# Appendix A

## Agency Coordination

**Appendix A Correspondence Index**

**Document 010**  
**National Aeronautics and Space Administration**  
**May 28, 2013**

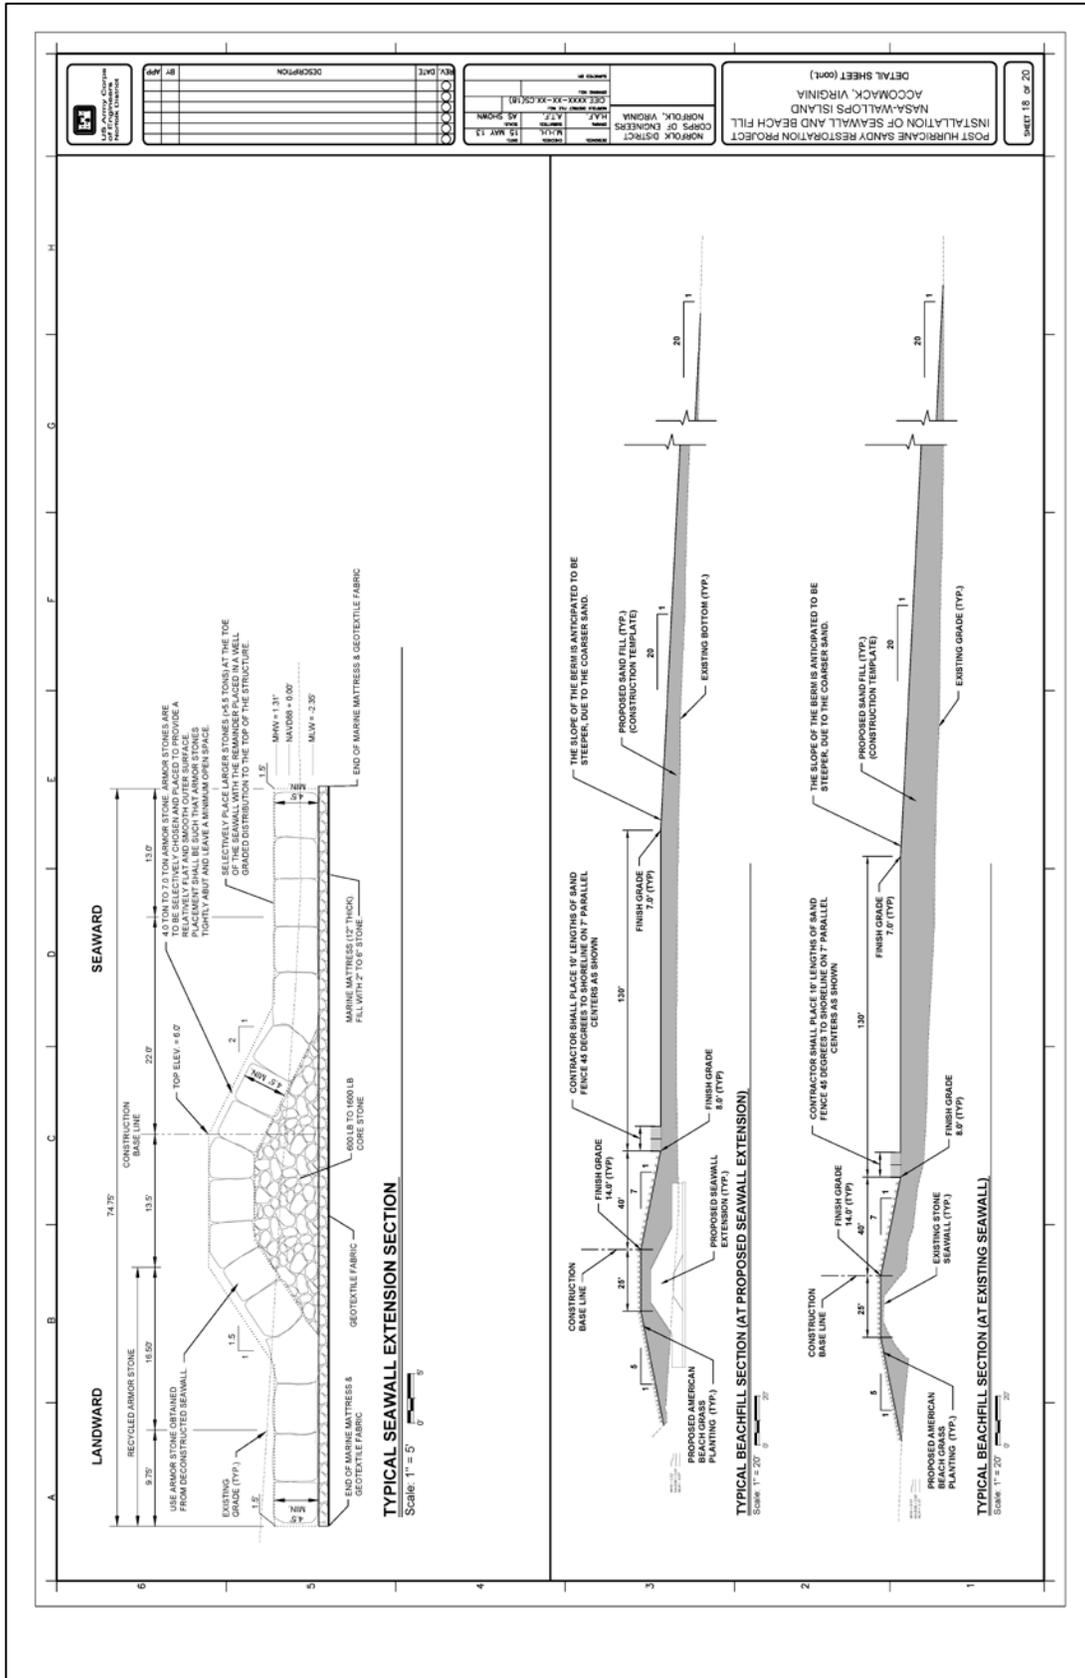
In consideration of the storm damage incurred during Hurricane Sandy, the project design team has recommended elevating the beach berm by an additional foot, which would change the berm's design template from +6 North American Vertical Datum of 1988 (NAVD '88) to +7 NAVD '88. A design drawing reflecting this change is enclosed. Aside from this modification, the design would not change from what is currently on file with VMRC and USACE. Of note is the fact that because the beach fill material has proven to be somewhat coarser than originally estimated, despite the proposed increase in berm elevation, the resultant steeper slope of the shoreface (>20:1) would keep the proposed footprint within the extent that has already been permitted.

The authorized modification will increase the beach elevation from six (6.0) feet to seven (7.0) feet (NAVD 88). As stated in your request the resulting subaqueous slope will still be within the permitted footprint. All other conditions of your permit shall remain unchanged.
